Re: Application No. 231069 (1960 Maciel Avenue); Storm Water Management Plan

RE: Application No. 231069 (1960 Maciel Avenue) as it may affect  
1922 Maciel Av, Santa Cruz; APN 029-121-01

Subject: 1960 Maciel Ave. 21-Lot Residential Subdivision  
Proposed Drainage Memorandum

Exhibit "A"

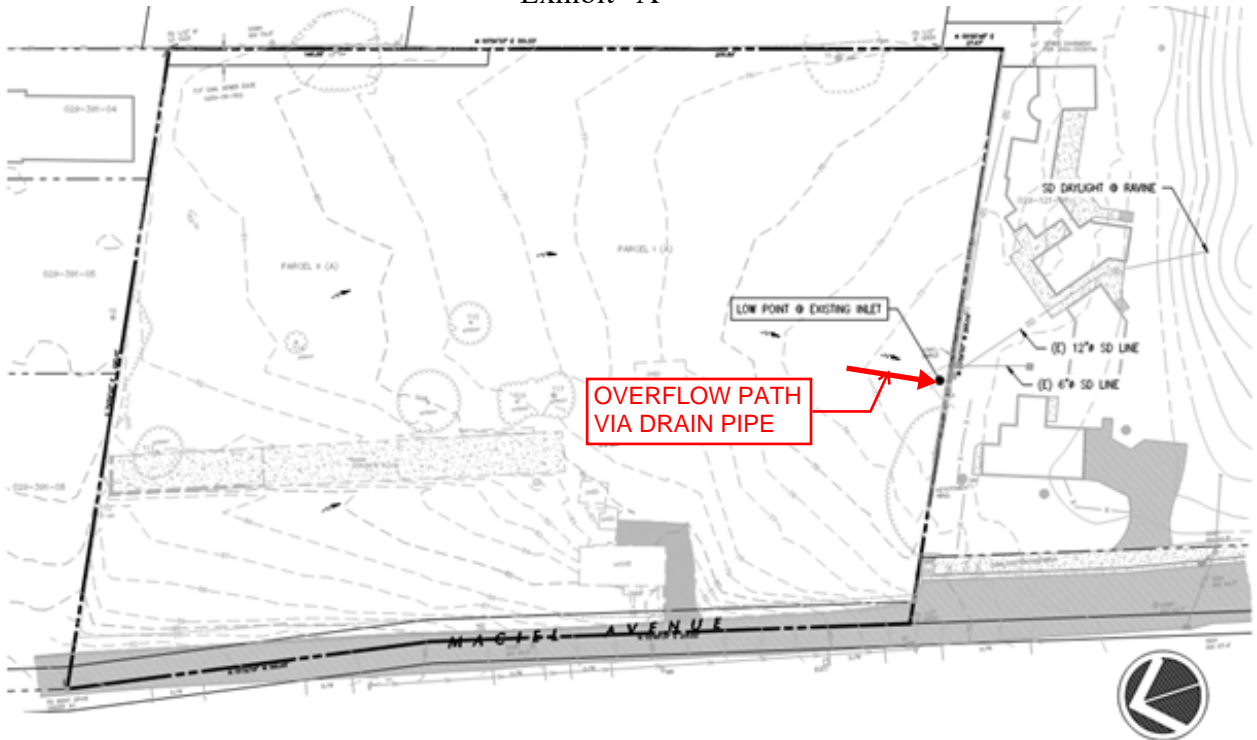
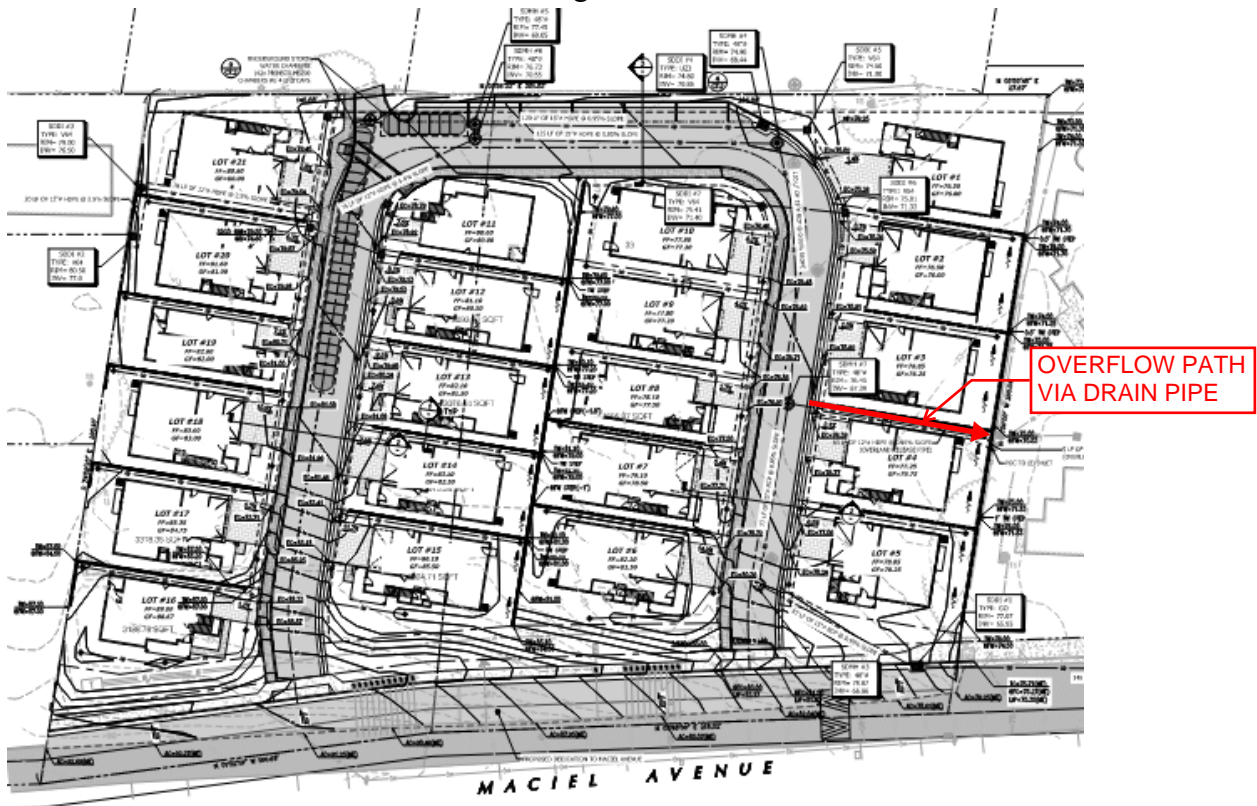
1. Sheet C5.1 shows "safe overland release" at the SE corner of 029-391-09 where it borders 029-121-01. In the attached letter dated May 1, 2024 from C2G Civil Consultants Group, it was stated that the overflow path would be relocated to the pre-development point of discharge. This is noted on page 12 of the Staff Report which reads "Safe overflow for storms exceeding 100-year storm design will follow existing patterns and route to an existing drainpipe located between lot numbers four and five." (This should read lot number three and four). The elevations currently shown in the plan set do not support this. The current grading from NE to SE shows a drop in elevation of more than 10 feet, with the low point being the SE corner of the parcel, which means that all overland water would flow to the SE corner of the parcel during a stormwater drainage system failure.

In addition to the calculations, the neighbor to the south of the proposed project expressed a concern with our previously proposed overland point-of-release (southeasterly corner). The previously proposed overland release C2G has revised the Safe Overflow Routing to meet the pre-development point-of-discharge. Below is Exhibit "A" which depicts the existing and currently proposed overflow path.

We agree to only accept the historical volume of storm water through our existing underground pipe near the border of Lots 3 and 4. We will not accept any overland surface release water.
